**Special Standard
 PUD Zoning District**

Project Name: GRANDVIEW PHASE II

PCD File No.: PUDSP-23-006

DEVIATION REQUEST (Attach diagrams, figures, and other documentation to clarify request)

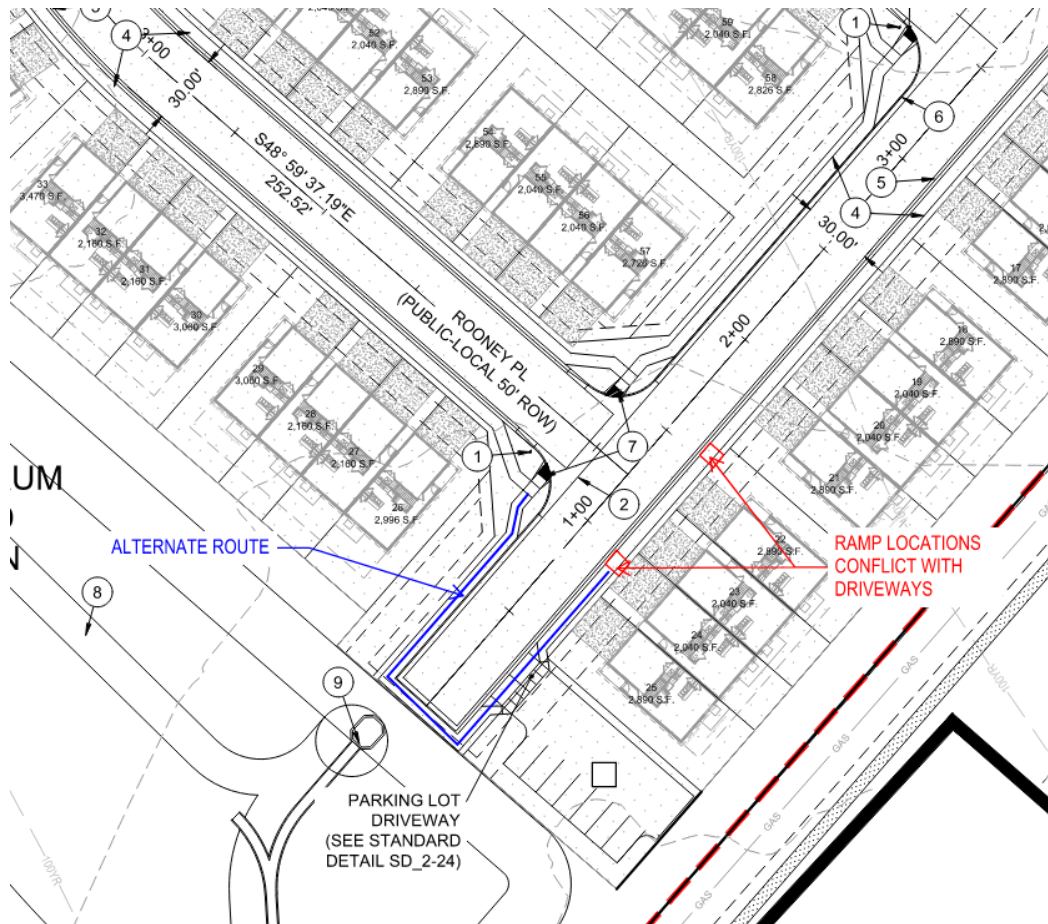
Deviation from Figure 2-36. All "T" intersections shall have a minimum of four access ramps as shown in Figure 2-36. A private access may be used as an access ramp provided it is designed to meet ramp requirements and it is within the intersection and directly across from other ramps. The townhome units are laid out in groups of 4 with very little separation between driveways. As a result, the access ramp will conflict with the driveways. (SEE EXHIBIT IN NEXT SECTION). The alternative is to provide an alternate pedestrian crossing. In this location, the pedestrian can cross the street via an alternate route 95 feet southwest of the pedestrian ramp landing.

- 1.) The deviation is based on a conflict with driveways, however, an alternate route over a 260' distance is provided. The layout of the townhome units minimizes this type of conflict across most of the site.
- 2.) The deviation provides an alternate route that meets minimum distances between ped ramps (600').
- 3.) The deviation enhances safety by providing a route that doesn't conflict with vehicle travel paths.
- 4.) The deviation will eliminate the need for maintenance on an additional ramp.
- 5.) The deviation has an insignificant effect on aesthetic appearance.

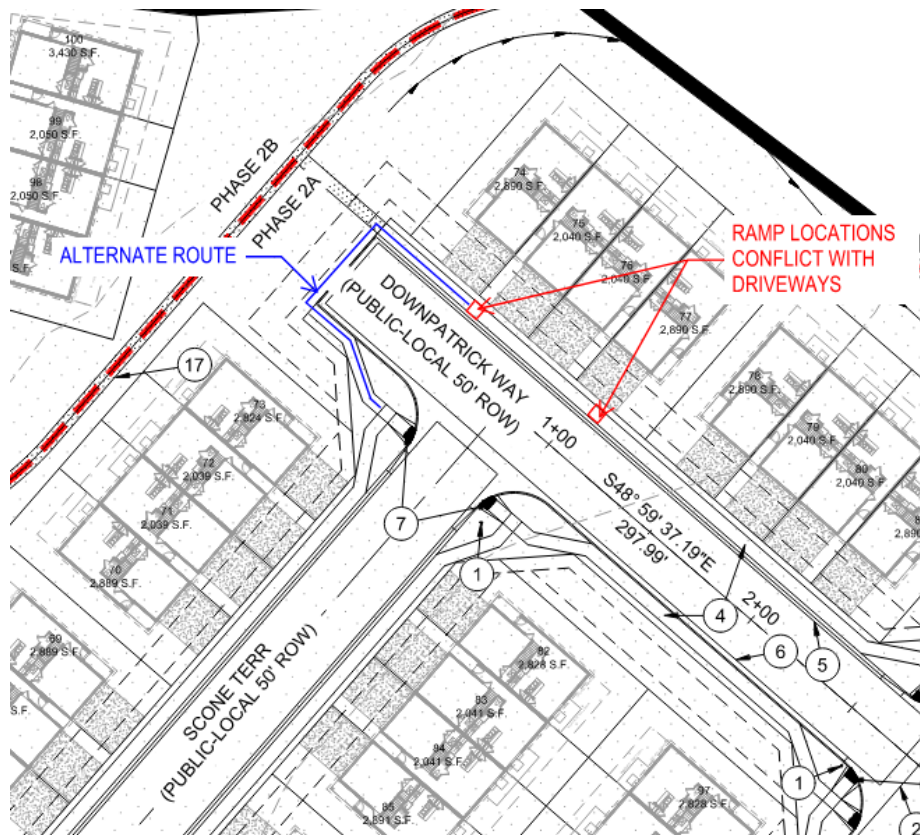
Deviation from Figure 2-36. All "T" intersections shall have a minimum of four access ramps as shown in Figure 2-36. A private access may be used as an access ramp provided it is designed to meet ramp requirements and it is within the intersection and directly across from other ramps. The townhome units are laid out in groups of 4 with very little separation between driveways. As a result, the access ramp will conflict with the driveways. (SEE EXHIBIT IN NEXT SECTION). The alternative is to provide an alternate pedestrian crossing. In this location, the pedestrian can cross the street via an alternate route 50 feet northwest of the pedestrian ramp landing.

- 1.) The deviation is based on a conflict with driveways, however, an alternate route over a 207' distance is provided. The layout of the townhome units minimizes this type of conflict across most of the site.
- 2.) The deviation provides an alternate route that meets minimum distances between ped ramps (600').
- 3.) The deviation enhances safety by providing a route that doesn't conflict with vehicle travel paths.
- 4.) The deviation will eliminate the need for maintenance on an additional ramp.
- 5.) The deviation has an insignificant effect on aesthetic appearance.
